MWO 9-2330-392-20-2

MODIFICATION WORK ORDER

MODIFICATION OF
TRAILER, CARGO: 2-WHEEL M1101
(2330-01-387-5443) EIC: CBC
TRAILER, CARGO: 2-WHEEL M1102
(2330-01-387-5426) EIC: CBB
CHASSIS, TRAILER: 2-WHEEL
(2330-01-387-5424) EIC: CCL

This modification is to provide a procedure for replacing the rivets used to secure the landing leg mounting bracket. Bolts and nuts will replace the rivets.

Figure 5

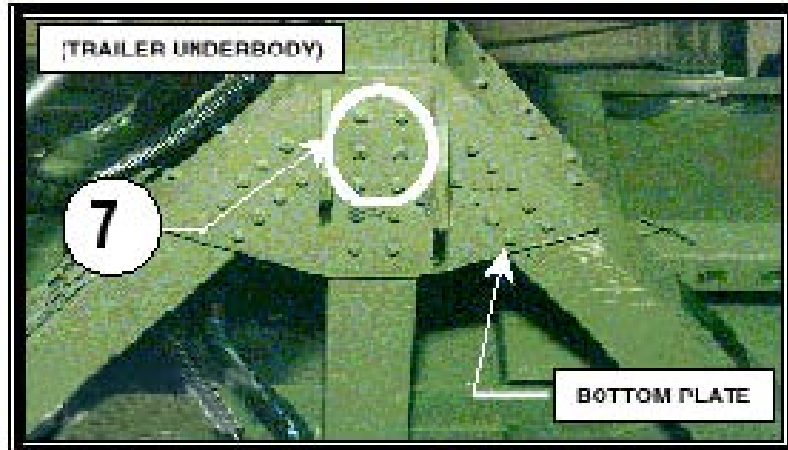
5. Locate and mark the six rivets (7) to be removed. Remove the six rivets (7) from landing leg mounting bracket attached to the bottom plate using one of the two methods described on following page. Store landing leg mounting bracket for later installation on this trailer (see **Figure 5**).

Figure 14

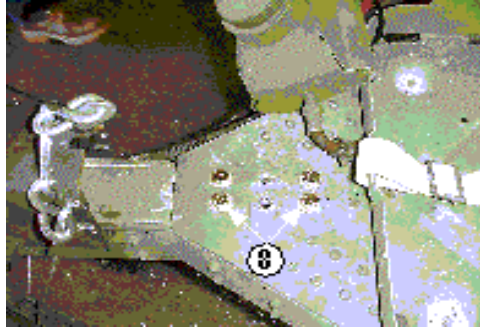
9. Before installing hardware clear away all drill shavings with a brush or pressurized air. Drop four of the 3/8" bolts (8) (with a flat washer) through the front two and rear two holes going through the drawbar (see **Figure 14**).

Figure 16

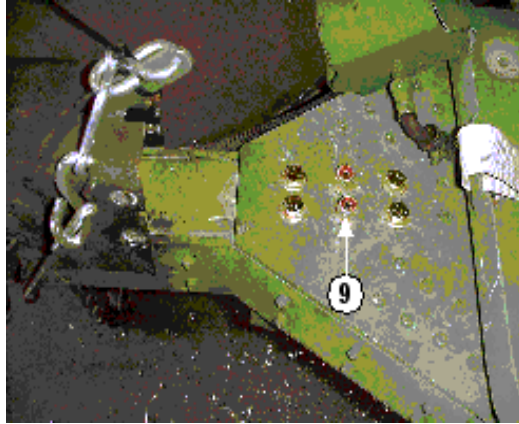
10. Secure the landing leg mounting bracket with four 3/8" locknuts & flat washers. Do not fully tighten the bolts/nuts. Insert two 3/8" bolts with flat washers from the bottom through the two middle holes and secure with 3/8" locknuts & flat washers (9). Torque all bolts to 35 ft·lbs. Recheck torque on all bolts (see **Figure 16**).

Figure 18

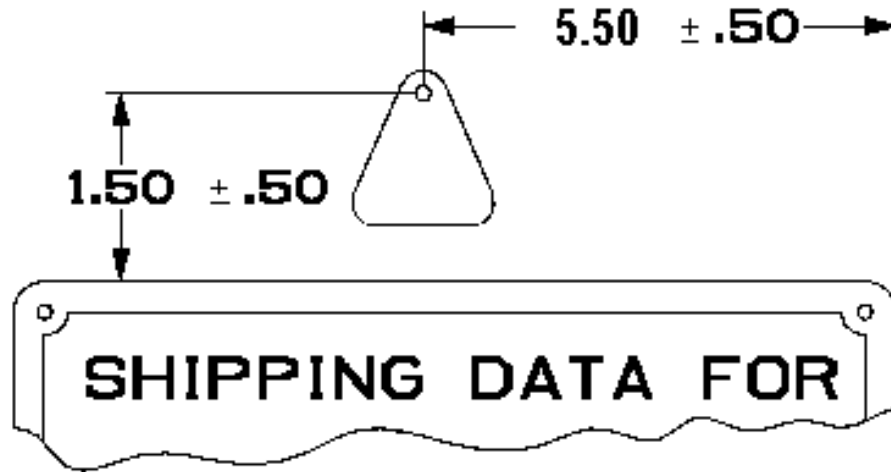
- 1) To install the MWO identification plate on cargo trailers, locate and drill a .129 - .133 inch diameter hole in the front cargo body above the shipping data plate (see **Figure 18**). Using a rivet gun and hand-set pull one rivet, P/N 12449496-1, from inside the cargo box fastening the MWO identification plate to the front cargo body. Installing the rivet from inside of the cargo box prevents any sharp edges on the inside wall of the cargo box.
- 2) To install MWO identification plate on chassis trailers, locate and drill a .129 - .133 inch diameter hole in the rear fender above the rear reflector (see **Figure 19**). Using a rivet gun and hand set pull one rivet, P/N 12449496-1, fastening the MWO identification plate to rear fender.
